DEVELOPMENT APPLICATION

APPLICATION NUMBER:	PLN-26-149
PROPOSED DEVELOPMENT:	Two storey extension to existing dwelling
LOCATION:	11 Philip Avenue, Montrose
APPLICANT:	A M Black and D R Black
ADVERTISING START DATE:	21/08/2026
ADVERTISING EXPIRY DATE:	4/09/2026

REQUEST FOR ADDITIONAL INFORMATION

RE: PROPOSED USE/DEVELOPMENT: TWO STOREY EXTENSION TO DWELLING
ADDRESS: 11 PHILIP AVENUE MONTROSE
APPLICATION NUMBER: PLN-26-149

SITE PLAN

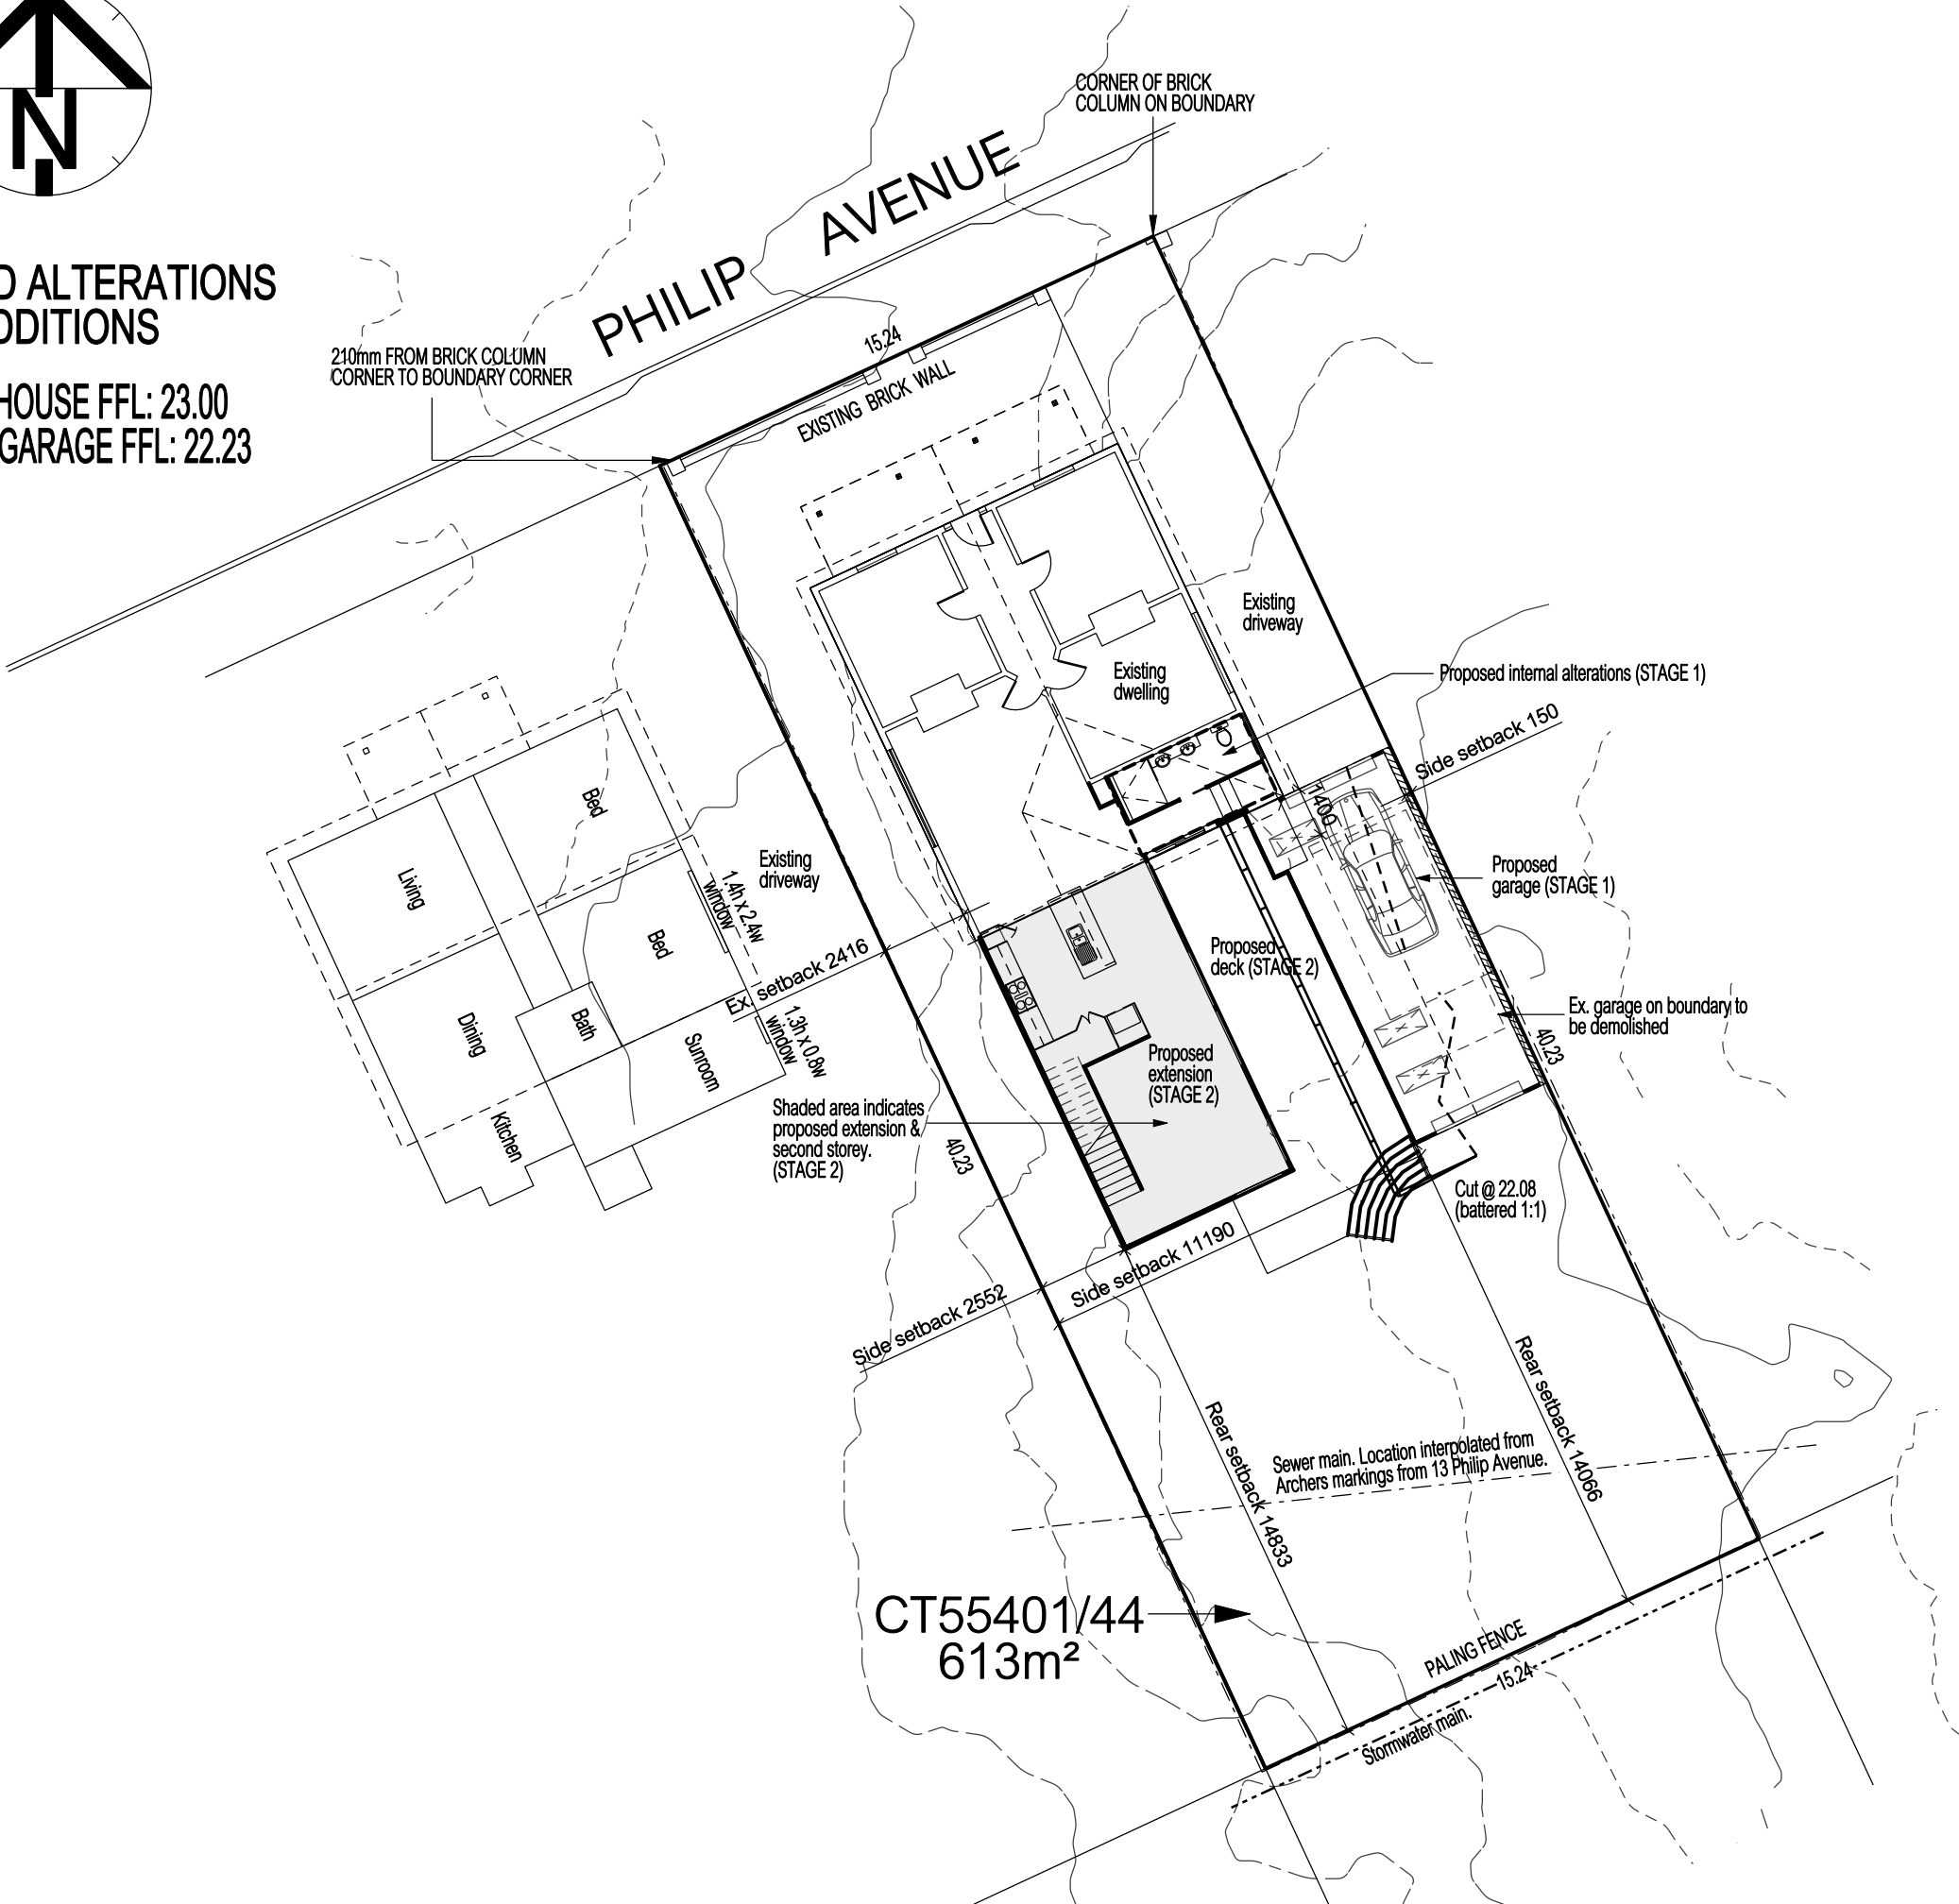
According to the Council's Stormwater Management Policy, any development that adds an impervious area greater than 40m² and exceeds the maximum allowed peak runoff must include OSD. For any additional impervious surface greater than 250m², please submit engineering calculations for the OSD design in accordance with the Council's Stormwater Management Policy.

The site has a total area of 627m², with a road/driveway measured at 43m² and a main house with roof and detached sheds/garages providing an impervious surface area of 237m². The remainder is assumed to be backyard/landscaped area. Whilst the backyard area has been conservatively generalised as pervious surface, it mostly comprises paved or concrete surfaces that may generate runoff. Figure 1 shows the breakdown of these surface areas in aerial view.

The new roof sees a reduction in the overall area down to 220m², whilst the proposed deck will occupy 43m². The driveway area will increase slightly to 48m², and the remainder of the property will continue to be a backyard/landscaped space (Figure 2). The new deck will be an elevated timber structure with open board spacing and will

Surface	Pre Development Area (m ²)	Post Development Area (m ²)	Change in Area (m ²)
Road/Driveway	43	48	+5
Roof	237	220	-16
BALANCE			-11

The proposed development will have no meaningful impact on the overall impervious area (it will result in a minor reduction), and as such stormwater detention is not required.

Figure 3: Tasmanian Planning Scheme – Code Overlay (Flood-prone areas) (Source: LISTmap).

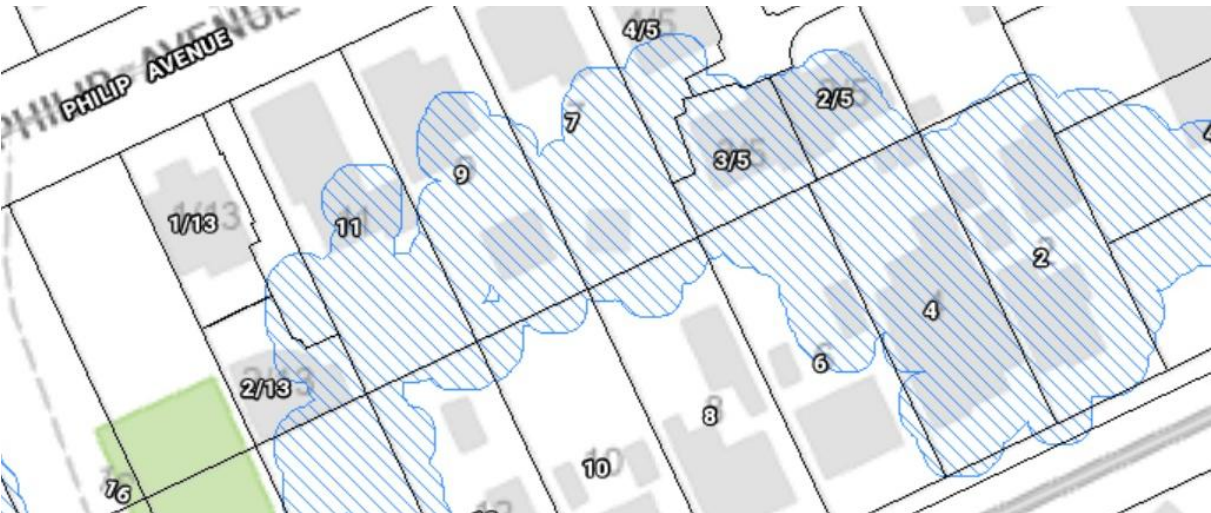
There are flood inundation issues identified through Council's records that affect the application. Documentation is required from a suitably qualified engineer to address performance criteria P1 of C12.6.1 (of the Planning Scheme- Glenorchy) and show that a building and works within a flood-prone hazard area can achieve and maintain a tolerable risk from flood; and buildings and works do not increase the risk from flood to adjacent land and public infrastructure.

The property requires assessment against the Flood Prone Areas Hazard Code as it is located within an area of inundation as per the Tasmanian Planning Scheme – Glenorchy. The flood prone areas code is displayed on the LISTmap and is presented below in figure 3.

The State Emergency Services (SES) have conducted more recent and detailed inundation mapping, and this is also available on the LISTmap. The SES mapping provides detail on various modelling scenarios, including the 1% AEP + Climate Change (CC) event which is required for assessment of the flood-prone areas code. Flood characteristics such as depth, velocity, and hazard rating can all be obtained from this data.

The 1% AEP+CC SES mapping shows the western side of the property sitting within a 100–250mm flood depth band. Other areas of the property are in the 100mm depth band, and the remainder of the property is outside the flood extent (Figure 4).

The deepest band of water across the property is the 100-250mm grid, which combined with the predicted velocities (0.1-0.2m/s) result in a worst-case flood hazard of only H1. This is the lowest level of flood hazard categorisation and is considered safe for people, vehicles, and buildings. As such, even assuming a maximum depth of water it can still be shown that the development is only exposed to a tolerable risk.

Figure 6: Southeast Elevation from architectural plans showing proposed FFL.

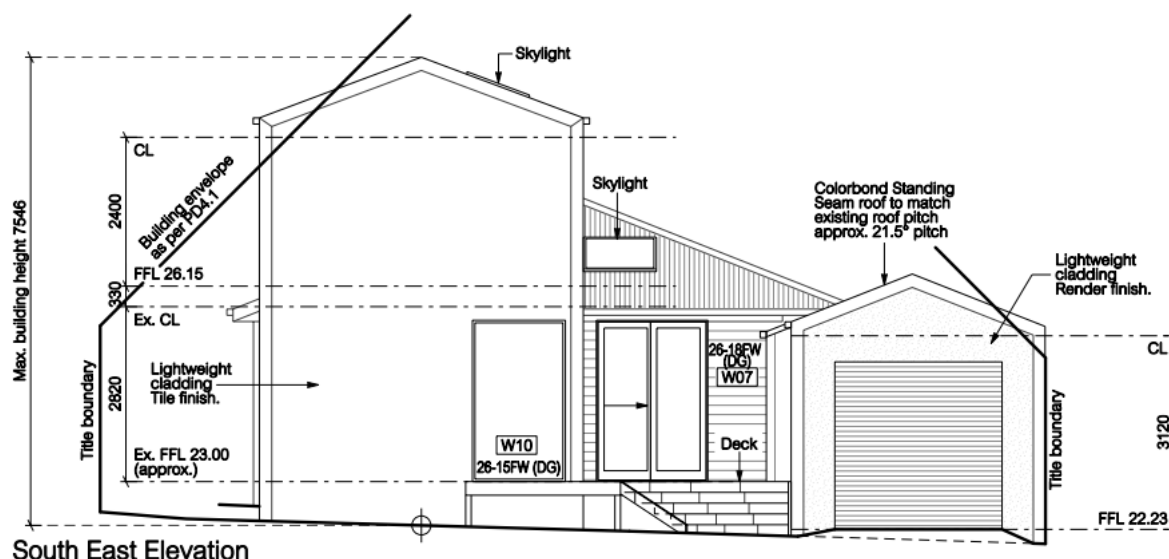
The FFL of the proposed garage is lower, at a level of only 22.23m AHD (Figure 7), which places it below the inundation level, but a garage is not considered a habitable space and as such it is not an NCC requirement to ensure there is 300mm freeboard from flood level to FFL. As the hazard rating across the property is only H1, the risk to the garage is also tolerable.

Under these conditions it is also possible to demonstrate the development would be compliant with the National Construction Code (NCC). Survey data confirms the approximate existing surface level adjacent to the proposed extension (which will be classified as a habitable room) is approximately 22.4m AHD. Adopting the 250mm flood depth results in water surface elevation of 22.65m AHD, which provides approximately 350mm freeboard to the proposed FFL of the extension – 23.00m AHD. This ensures the

minimum freeboard of 300mm to habitable rooms required by the NCC can be achieved and supports the conclusion that the risk to the proposed development is tolerable.
